PROJECT TO CONSTRUCT A NEW ENTRANCE BUILDING FOR
VENDÔME MÉTRO STATION AND A NEW PEDESTRIAN LINK TO
THE MCGILL UNIVERSITY HEALTH CENTRE (MUHC)

PUBLIC CONSULTATION COMMISSION REPORT TO THE SOCIÉTÉ
DE TRANSPORT DE MONTRÉAL (STM) BOARD OF DIRECTORS
ASSET MONITORING COMMITTEE

MARCH 2017

Figure 5 – Plan illustrating the partition between the métro’s south platform and the AMT area

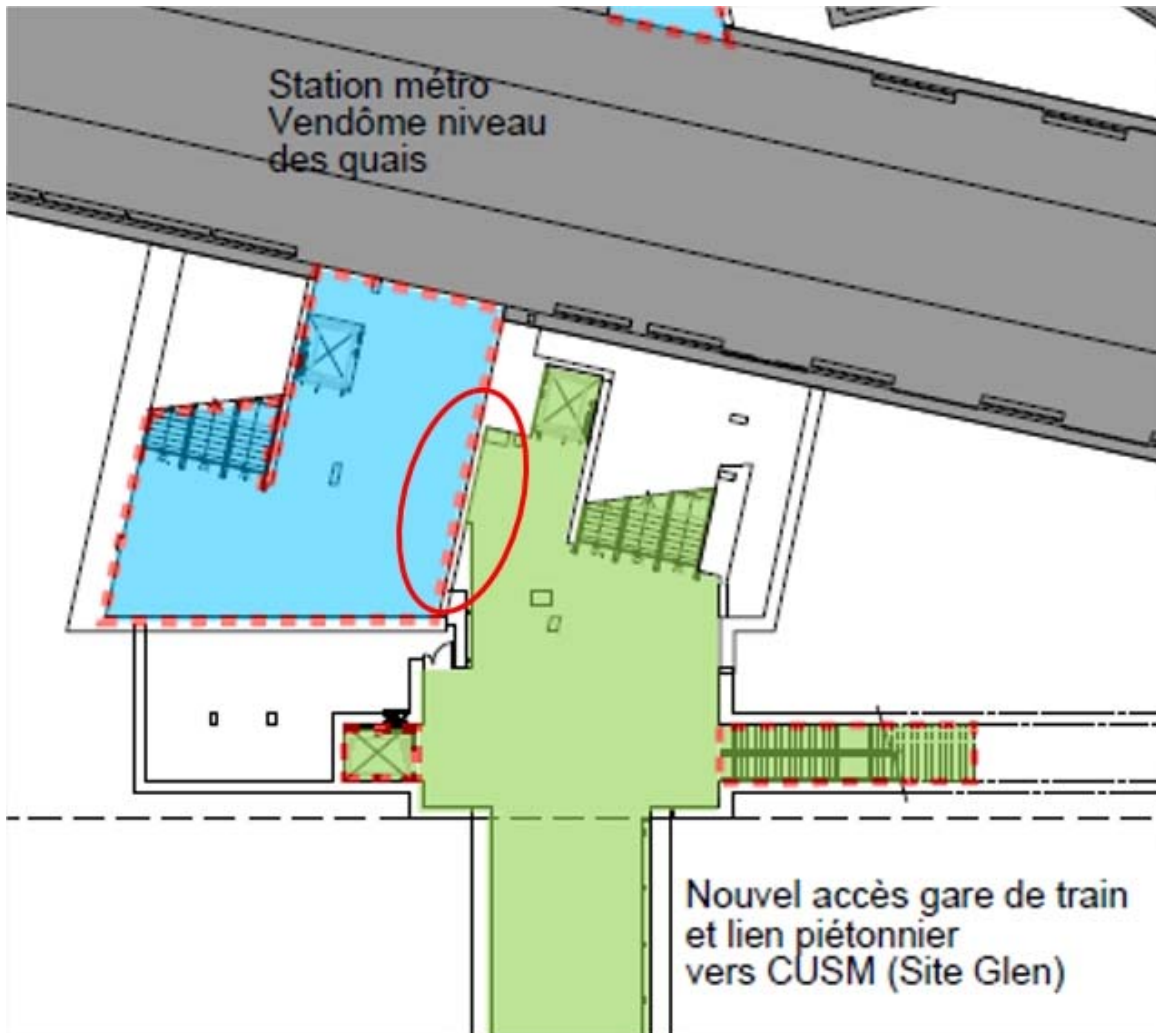
The need for (or position of) the partition separating, within the tunnel, the fare-paid zone of the métro station, eastbound south platform, and the non-fare-paid zone from the AMT, was put into question and it was suggested that the spaces be redesigned to allow for fast, direct access to and from the eastbound south métro platform, thereby saving AMT and other users of the corridor leading to the MUHC from having to travel up to the entrance building only to go back down into the métro station to access the métro. The Commission also considers that the layout in its currently planned form is sub-optimal and suggests that the STM explore the possibility of shortening the journey as proposed above.

The Commission considers that some of the suggestions received deserve to be examined closely by the STM and its partners with the aim not only of improving the project's intermodality, but also of shortening the journeys and number of stairs to climb or go down.

Recommendation 6.

The Commission recommends that the STM review the construction plans to assess the feasibility of:

1. Removing the partition separating, within the tunnel, the fare-paid zone of the métro station and the non-fare-paid zone leading from the AMT station and including exit turnstiles and, if possible, one or more métro entry points (without attendants) to provide fast and direct access to and from the eastbound métro platform, thereby saving AMT users from having to travel up to the entrance building only to go back down to the métro station.
2. Adding escalators wherever possible.
